Staff Report
City of Richmond, Virginia

Commission of Architectural Review

5. COA-114615-2022	Conceptual Review Meeting Date: 7/26/2022
Applicant/Petitioner	Joseph Yates
Project Description	Construct a new two-story rear addition.
Project Location	
Address: 516 N. 26 th Street	
Historic District: Church Hill North	
High-Level Details: <ul style="list-style-type: none"> The applicant requests approval to rehabilitate the exterior of a circa 1920 frame dwelling and to construct a two story rear addition. Exterior rehabilitation includes removing existing vinyl siding, and posts, and restoring/replacing in-kind with wood posts and wood siding. Fiber cement siding will be installed on minimally visible elevations. Vinyl windows will be removed and replaced with aluminum clad wood windows. Damaged/deteriorated wooden elements such as the cornice, molding, trim, and sills will be repaired/ replaced in-kind. The applicant proposes to remove a deteriorated, one-story projection from the rear and to construct a two-story rear addition and covered porch. The addition will be as tall as the existing dwelling, and will have a gable roof form, cementitious siding, and aluminum clad wood windo

Figure 2. Photo approx. 1954

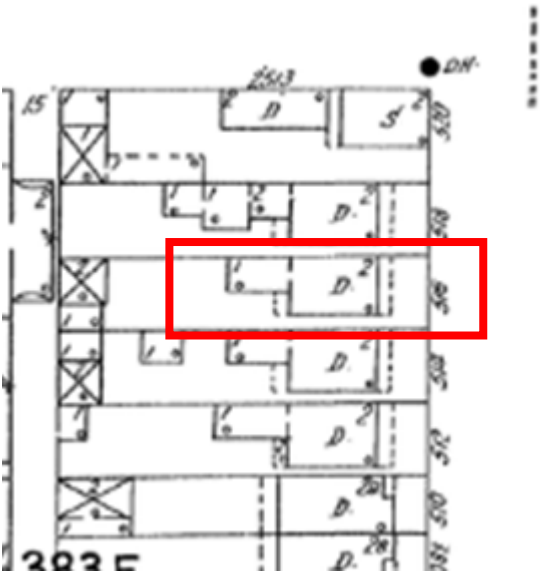
Guideline Reference	Reference Text	Analysis
Siting #1, pg. 46	<i>Additions should be subordinate in size to other main buildings and as inconspicuous as possible. Locating additions at the rear or on the least visible side of a building is preferred.</i>	<p>The applicant is proposing a two-story addition to the rear of the existing dwelling. The proposed addition will be flush with the wall plane of the existing dwelling. To better differentiate the new addition from the original massing of the dwelling, <u>Staff recommends that the new addition be inset at least six inches from the massing of the main dwelling.</u></p> <p>To make room for the addition, a rear, “L-shaped” one story portion of the dwelling will be demolished. The applicant’s report states that the existing rear one-story portion of the dwelling is in disrepair, and most of its interior and exterior historic fabric has been removed.</p> <p>City Assessor’s records indicate that there was a fire in the late 1970’s that condemned the dwelling, and it was gutted and boarded up until the mid-1980’s when the fire damaged areas were repaired. It is unclear from the</p>

<p>assessor's record which portion of the dwelling was impacted by the fire, but this evidence would confirm that substantial alterations to the historic fabric of the dwelling have already been undertaken.</p> <p>Based on the 1924-1925 Sanborn Maps Staff was able to determine that the rear one-story portion of the dwelling is likely original, and that the shorter portion of the this "L-shaped projection was an open porch, but enclosed sometime after 1950.</p> <p><u>Staff requests that the applicant provide more information and documentation on the existing conditions of the rear one-story portion of the house, including existing elevations.</u></p> <p>According to the applicant's report, the new addition would be approximately 10 feet longer than the existing rear projection. The addition appears quite large, and is the same height as the existing dwelling.</p> <p><u>Staff recommends that the roof of the main addition be lower than the roof peak of the original, two-story portion of the dwelling.</u></p> <p><u>Staff recommends that information on the square footage of the new addition, and the square footage of the existing dwelling be submitted with final review</u></p> <p>During conceptual discussion, staff recommends that the Commission consider the proposed size of the new addition in relation to the remaining original dwelling, as well as consider the merits of the proposed demolition of the rear portion of the dwelling.</p>
